Attachment for steering gearboxes JRM482, JRM484, JRM485, JRM486, JRM491, JRM496, JRM584, JRM7491, JRM7584

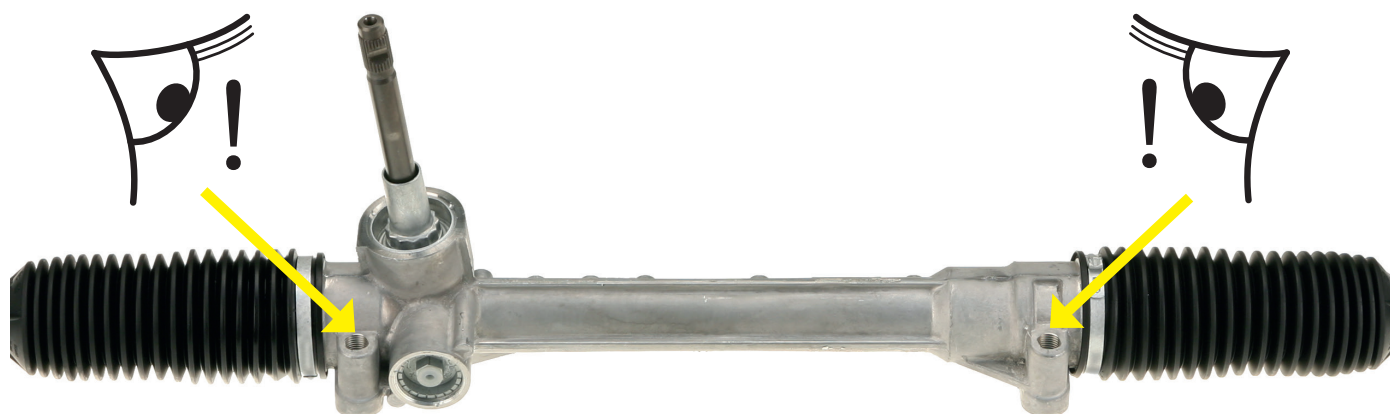
Due to a change in the series production, the steering gearboxes mentioned above have two different types of attachment threads - M12x1.25 and M12x1.75. For this reason, the thread pitch of the steering gearbox must be checked before installation. To check this use a thread gauge or turn the bolts by hand into the thread. The bolts must turn several times without using any specific force.

**Note: Using the wrong bolts will lead to the destruction of the steering gearbox!
When replacing a steering gearbox TRW generally recommend the renewal of the attachment bolts.**

Bolt M12x1.75
Ford OE number: 1774878
Fiat OE number: 51915330

Bolt M12x1.75
Ford OE number: 1675335
Fiat OE number: 51856874
